Delegated Report		Analysis sheet	Expiry Date:	28/08/2014
		N/A / attached	Consultation Expiry Date:	02/10/2014
Officer			Application Number(s)	
Eimear Heavey			2014/3640/P & 2014/3806/L	
Application Address			Drawing Numbers	
Renoir Cinema Brunswick Centre Brunswick Square London WC1N 1AW			Refer to decision notice	
PO 3/4	Area Team Signature	C&UD	Authorised Officer Signature	
Proposal(s)				
Erection of a roof extension above cinema entrance to provide restaurant / cafe (Class A3).				
Recommendation(s):	Refuse Planning Permission Refuse Listed Building Consent			
Application Type:	Full Planning Permission

The proposal is for the erection of a roof extension above the Renoir Cinema entrance to provide a restaurant/cafe (Class A3).

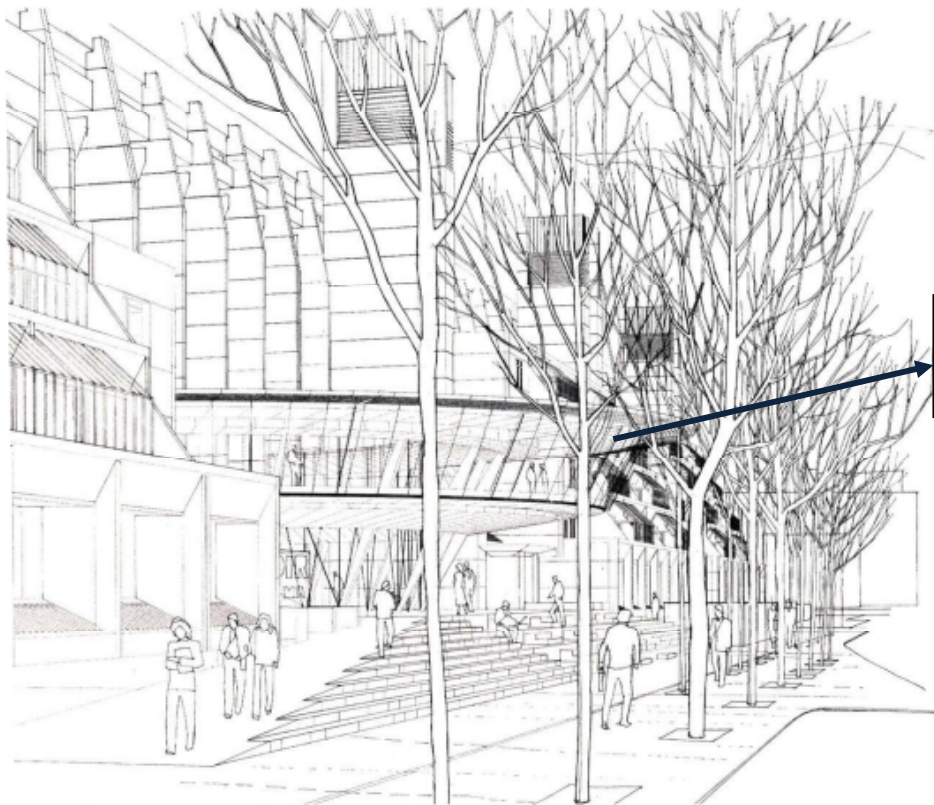
Concerns are therefore raised regarding the addition of a further storey above and beyond the roof of the Renoir entrance enclosure, which will harm both the visual and the physical permeability outlined in the paragraph above. The main body of the proposed Eyecatcher will not only be wider than the Renoir enclosure, but will include an entrance staircase, lift tower and service run on its northern side, removing valuable pedestrian circulation space for the shopping centre entrance.

Additionally, it will have a substantially deeper plan as a cantilevered structure from east to west, which will dominate the entrance and vastly alter the spatial characteristics and sense of openness in this area of the Centre. Furthermore, it will add a further storey wedged between the concrete structural columns of the entrance which will not only compromise the openness and block the important views but will compromise the sense of verticality behind the architectural composition of the entrance.

Issues are also raised regarding the depth of the cantilevered Eyecatcher. Whilst the western end of the proposed extension projects to approximately the rear line of the restaurants facing the central shopping mall, the eastern end projects a notable distance forward of the Renoir enclosure, dominating the paved forecourt space in front of the entrance steps, to the degree that its eastern façade is just behind the existing bike stands, ie only a couple of metres behind the top of the entrance steps. The applicant has stated that this line cannot be set back further as the floor area for the proposed restaurant cannot be reduced (this is despite the absence of detailed restaurant layout plans).

This element of the scheme is of particular concern since the cantilever will project a notable distance forward, dominating the paved area in front of the entrance by hovering in a somewhat menacing way over the pedestrian level, assisted by its structural latticework which will jar with the verticality of the existing concrete columns. The impact of the cantilevered structure will therefore harm the spatial qualities of the grade II listed building, visually compromise its structural elements and architectural composition, block important views within and around the listed building and conservation area. In particular the eastern projection of the cantilever will impact negatively on important views with the Bloomsbury Conservation Area, in particular views from Brunswick Square Gardens, a grade II listed Registered Park and Garden and London Square.

Concerns are raised regarding the detailed design of the proposed Eyecatcher, in terms of structural concept, use of materials including large areas of glazing, and general architectural detail. The selected architectural vocabulary of the Eyecatcher is deliberately in contrast to the solid concrete Brutalism of the existing grade II listed building, generally characterised by a metal and glass construction.

Although these materials are in principle acceptable, there is concern that the pattern, distribution and proportions of the materials is out-of-keeping since the structural latticework and the cladding pattern of varying widths of slats on the flank walls of the cantilevered extension will clash with the modular design of the megastructure including the strong vertical concrete columns and other existing elements including the A-frame sections of the adjacent residential blocks.

It is acknowledged that the large areas of glass, particularly on the east and west elevations, will give a generally lightweight appearance, the use of large areas of glazing on all sides of the scheme will make the extension highly visible in hours of darkness. It will act as a beacon at night, overlooking and being highly visible from the Bloomsbury Conservation Area in particular the sensitive context of Brunswick Square, which is a designated London Square and grade II listed Registered Park and Garden. This light effect will also over-dominate the eastern entrance to the Centre.
